SERVICE BULLETIN SB00.23

Machines/Models: X31N

PURPOSE: Add Weight to the Chassis

Figure 1

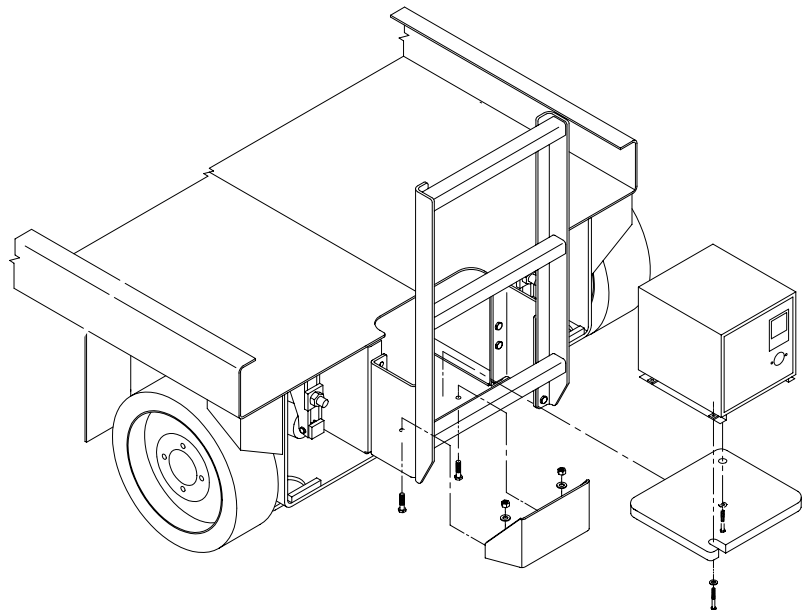
1. Remove the battery charger gaurd attaching bolts and remove the battery charger gaurd (retain hardware for reinstallation) (see Figure 1).
2. Remove the mounting hardware from the battery charger (see Figure 1).
3. Lift the battery charger and insert the supplied weight in place (see Figure 1).
4. Align the mounting holes and install the supplied screws, washers.
5. Torque the installed hardware to 110 In lbs (12 Nm).
6. Reinstall the battery charger gaurd with the original hardware.
7. Torque the battery charger gaurd hardware to 25 ft lbs (35 Nm).
8. Perform Pre-Operation and Safety Inspection as instructed in the Operator Manual to ensure proper operation of machine.
